Regulation No. XXX**UNIFORM PROVISIONS CONCERNING THE APPROVAL OF
I EMERGENCY CALL DEVICES (AECD)
II VEHICLES WITH REGARD TO THE INSTALLATION OF AN
AECD OF AN APPROVED TYPE
III VEHICLES WITH REGARD TO THEIR AECS****Contents****Preliminary comments from the Secretary of GRSG informal group on AECS**

2. This document is an attempt to show the status of the discussions after the 9th meeting of the informal group. The changes compared to AECS-02-02-Rev.4 (status after 8th meeting) are indicated in bold and strikethrough characters, save for Part III for ease of reading and because it was not discussed at AECS-09.

Figure 1
Generic description of test pulses

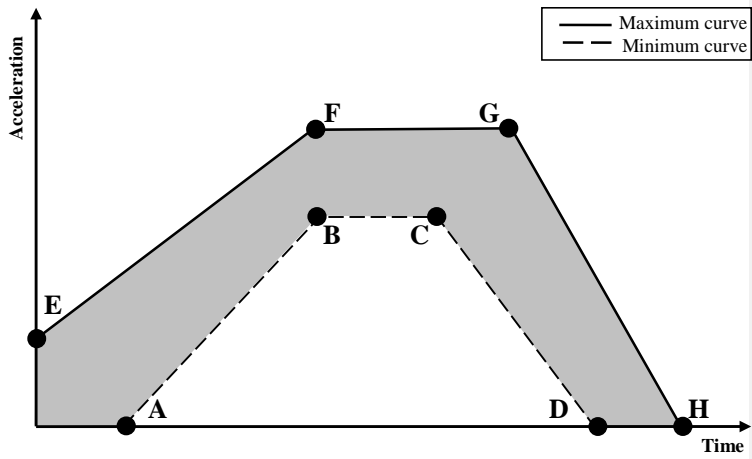
Commenté [T28]: We request a waiver to higher peak deceleration requirement.
Note:
 It is understood that the peak acceleration curve proposed by TRL pulse test includes accidents that are certainly leading to fatalities only.
 We understand that the resistance of the AECD should be demonstrated for non-fatal accidents only and not for accidents leading to expected fatalities.

Figure 1: Open sky definition

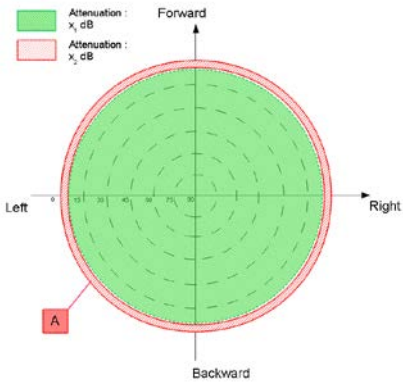
Commenté [T30]: The area A description should be "-100 dB or signal is switched off" which is same as Figure 3 Urban canyon definition 2) Urban canyon plot attenuation.
